# **Bexhill to Hastings Link Road**

## **Addendum to the Environmental Statement**

### **Supplementary Information - Hydrology**

**August 2008**

**Figure 2**  
Indicative Cross Sections  
Powdermill Valley Pond

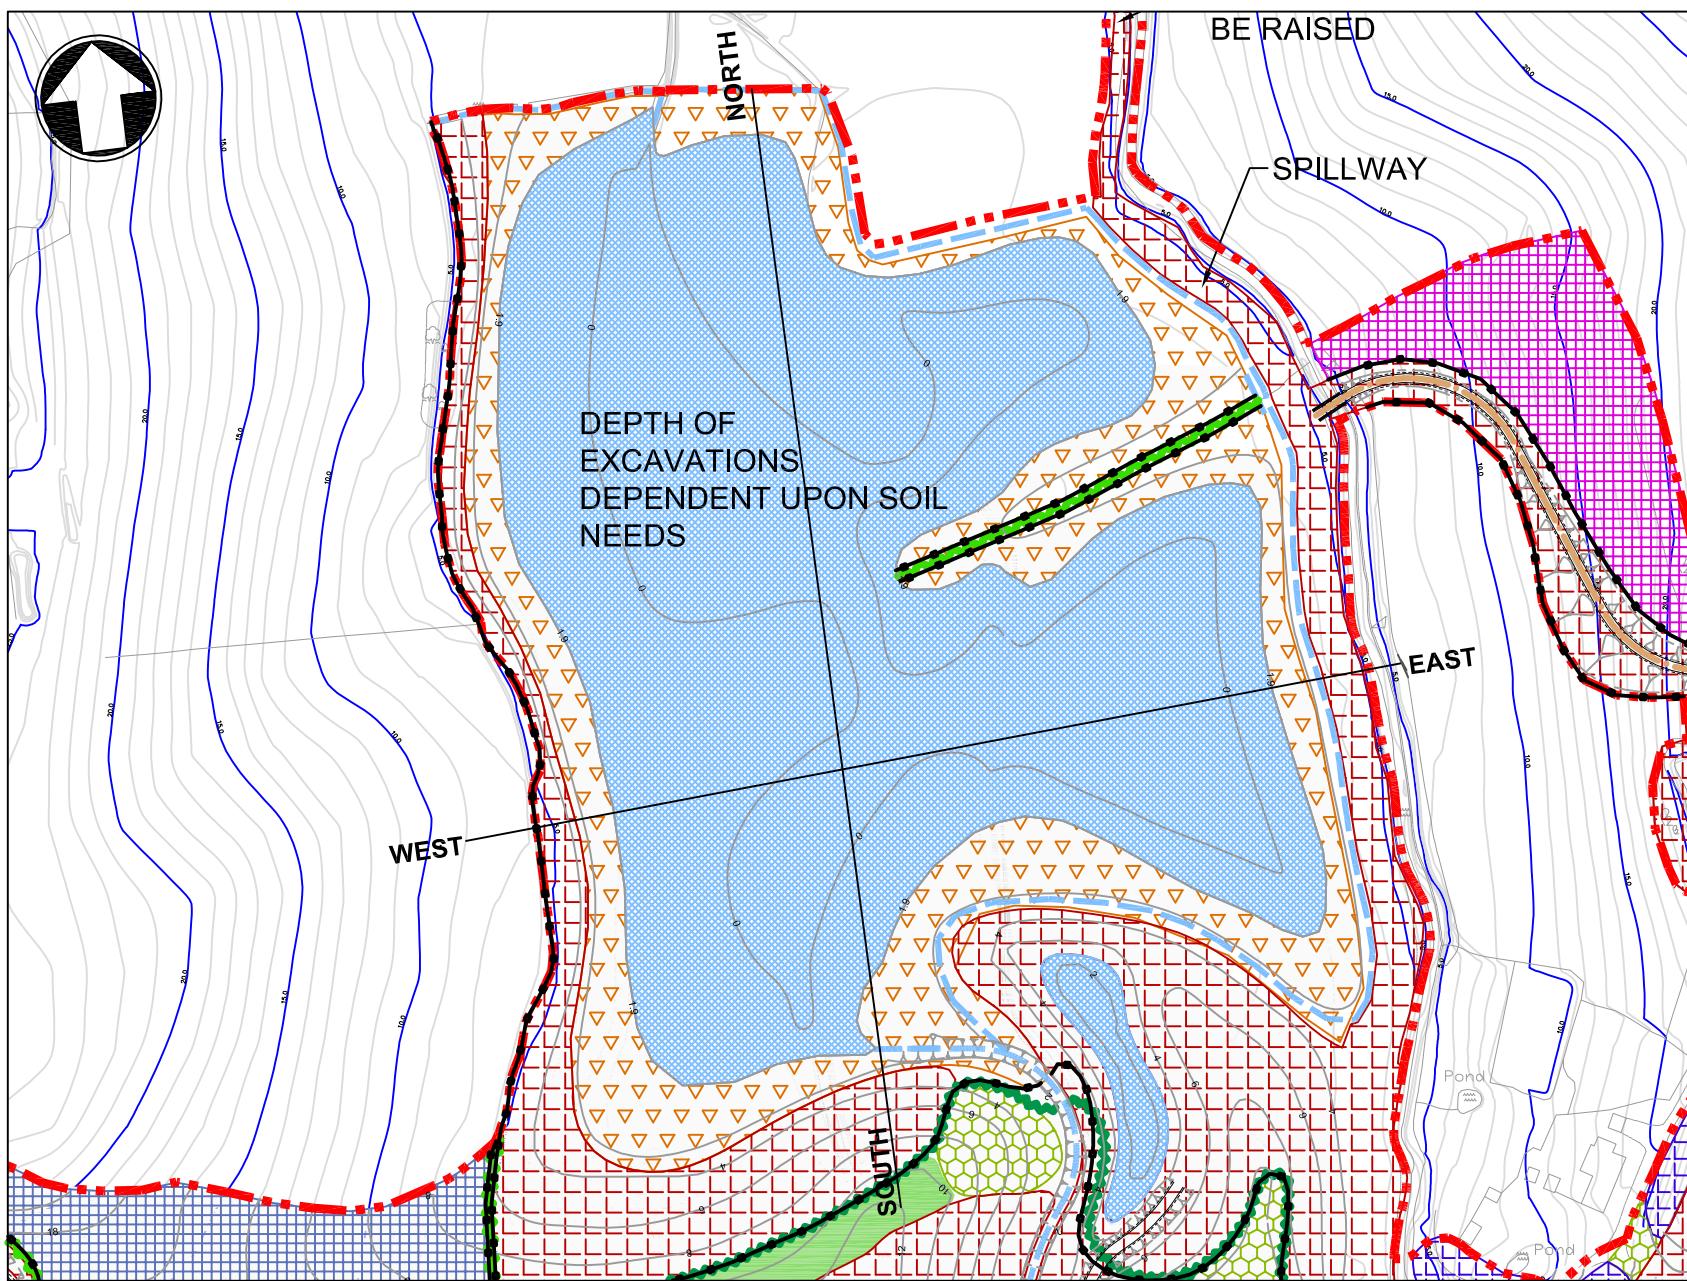
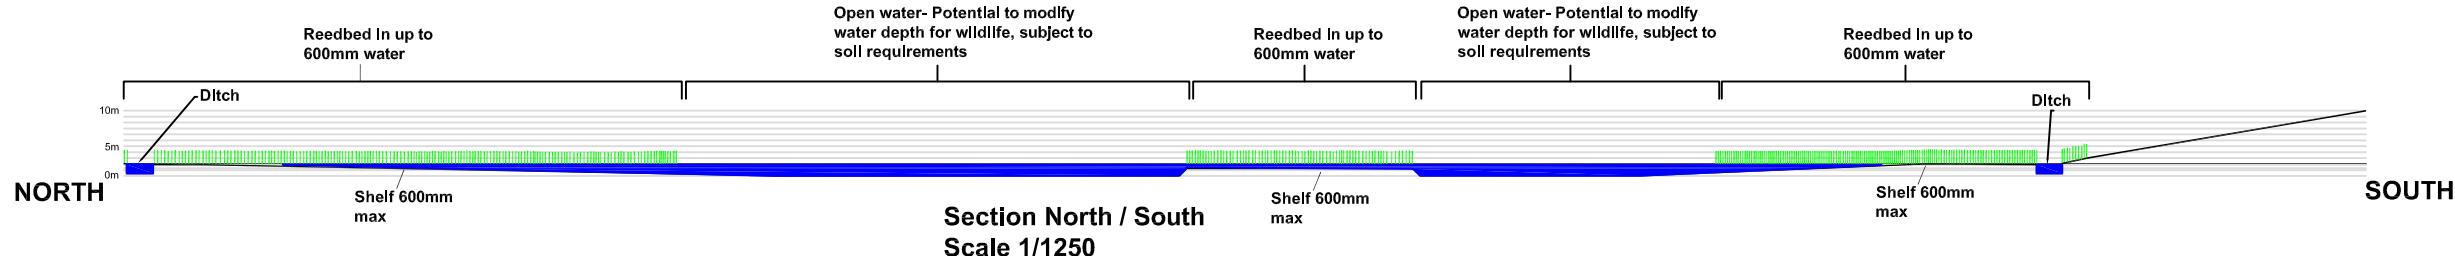
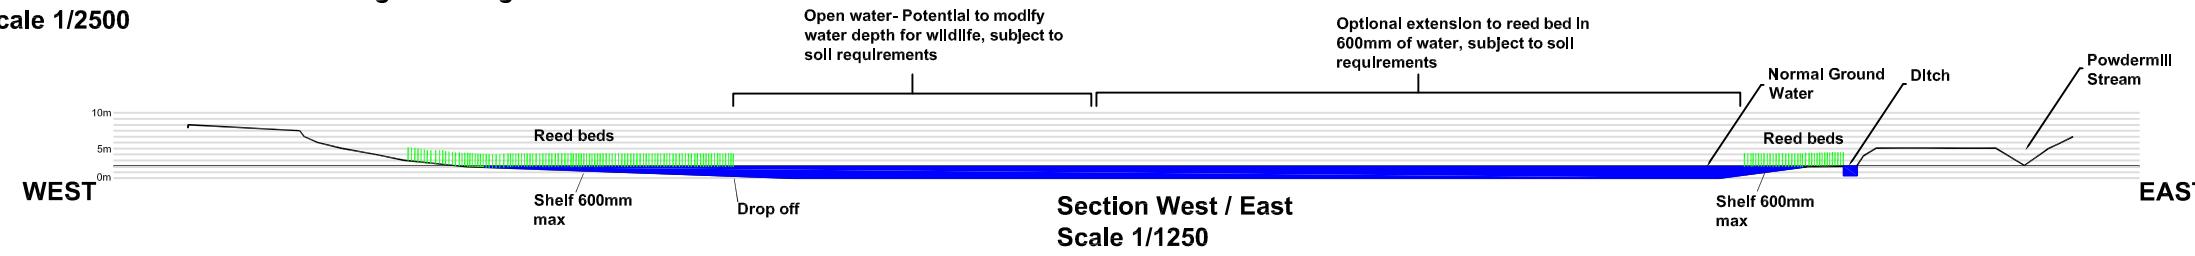
- 2.1 **Additional information to be provided to support the creation of the replacement wetland habitats, particularly relating to the suitability of the Powdermill borrow pit.**

- 2.1.3 At this preliminary stage in the Scheme design, it is not possible to be definitive regarding the final form of the Powdermill Valley wetland. Such detail will become clear at the detailed design stage of the Scheme. Figure 2 contained in Appendix E to this report provides an indicative illustration of Powdermill Valley borrow pit in cross section.

- 2.1.4 In order to maximise flood storage capacity, the whole of the Powdermill Valley area would need to be excavated to 1.9mAOD. This depth is the normal ground water level, and exhibits only marginal seasonal fluctuations, as demonstrated through groundwater monitoring. Appendix C of this report containing Figure 9.3 (taken from Volume 3 Part 1 of the ES) identifies all borehole locations for the Scheme. Boreholes 14 and 15 are located within the Powdermill Valley area. Graph 1 contained in Appendix D illustrates the recorded groundwater levels for these boreholes between March 2006 and June 2007. The data shows that over the course of 15 months groundwater only fluctuated by a maximum of 10cm.

- 2.1.5 Water depth and bank slope profile of the proposed borrow pit will define the character and biodiversity of the wetland. The borrow pit will be designed where appropriate with a sloping profile and varying depths. Marginal depths will remain shallow in order to support common reed communities grading into drier reedbeds and wet grassland rush pasture communities.

- 2.1.6 Reedbeds are able to tolerate eutrophic still waters with a substrate of clay, silt and peat. Reedbeds will thrive in depths of up to 1.0m (Newbold, C and Mountford, O, 1997) and can tolerate periodic inundation.

- 2.1.7 It is anticipated that a greater amount of soil than derived from a 1.9m AOD excavation would be needed for the construction works. Therefore, in order to generate a good quality reed bed, it would be appropriate to excavate to an undulating depth, generally up to 600mm deep and no more than 1m, to create standing water beneath the reeds. As a minimum, such a reed bed would be created on a shallow “shelf” around the inside perimeter of the area to create a marginal reedbed habitat. The surface of this area would be left as a rough scrape to aid reedbed and marginal emergent macrophyte establishment. The primary reed donor source would come from the dredging of ditch banks which would be removed by the Scheme, and translocated into the newly created marginal “shelf”.

Dwg No: Figure 3

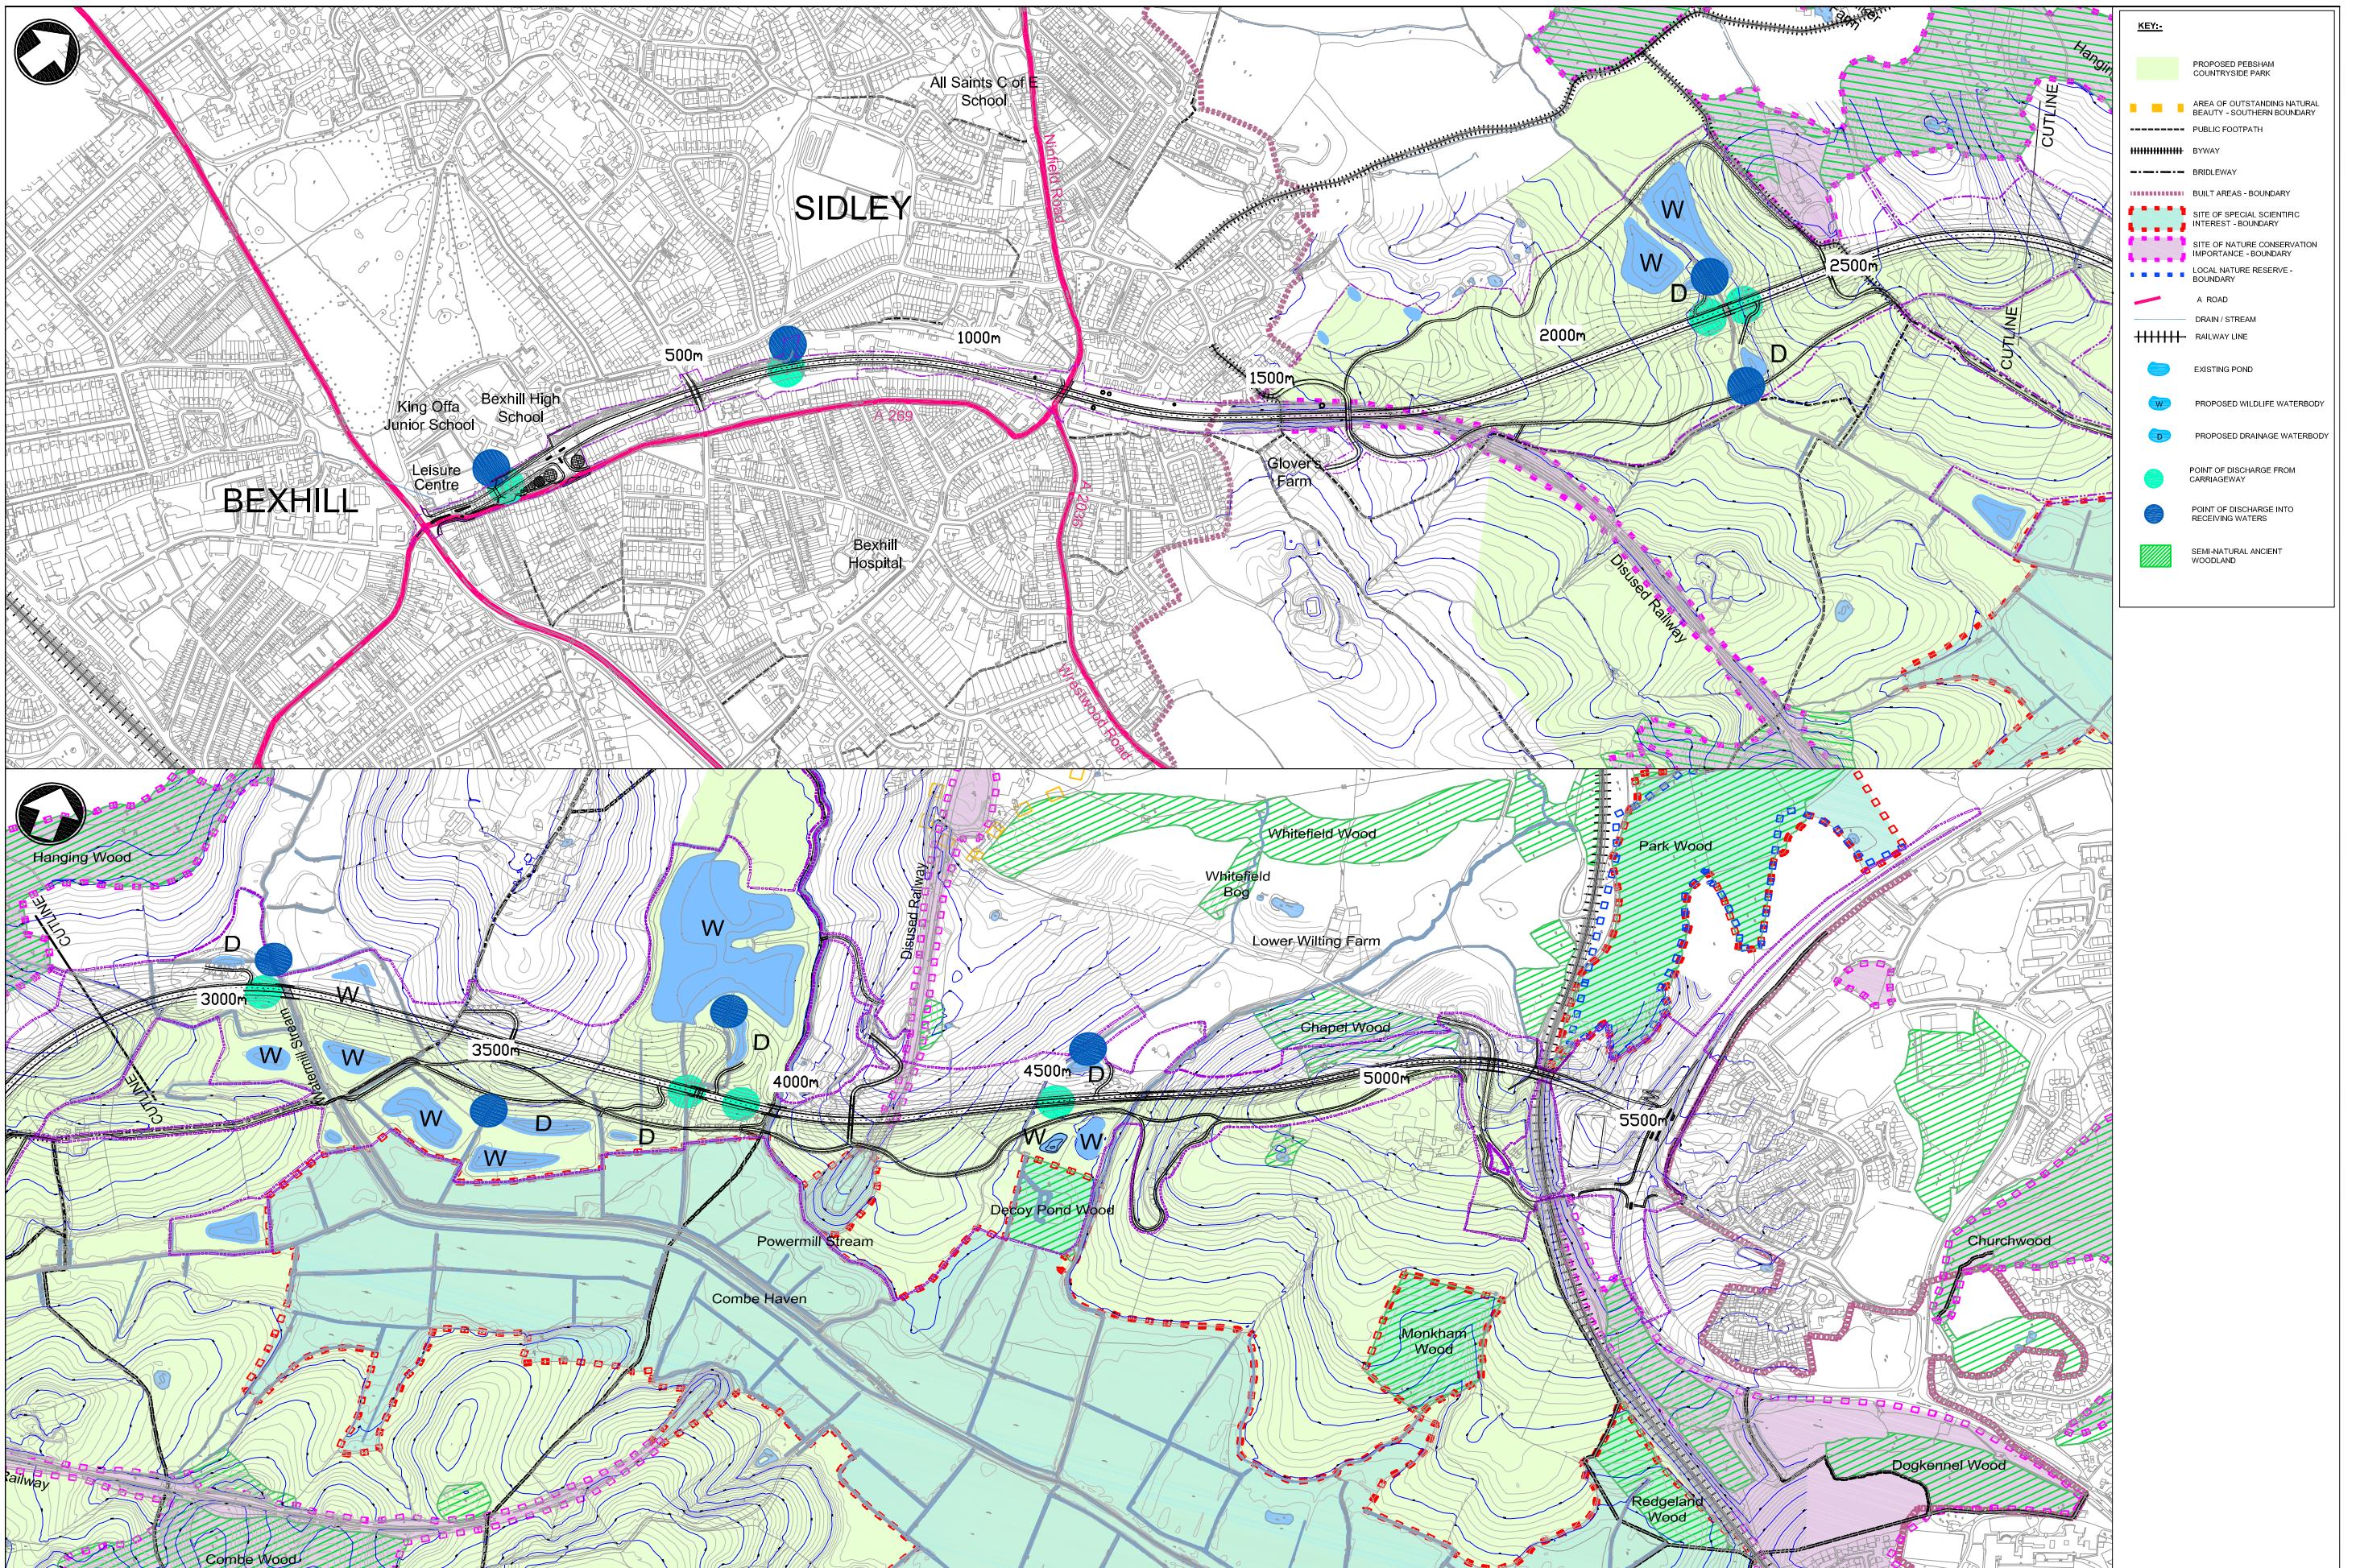
- 2.3.3 EA also suggested that mitigation could include diverting outflows away from sensitive habitats where possible. A commitment was subsequently made to map the discharge points in relation to sensitive sites.

- 2.3.4 Figure 3 contained in Appendix F of this report identifies the drainage outfalls and sensitive environmental sites within the Scheme alignment.
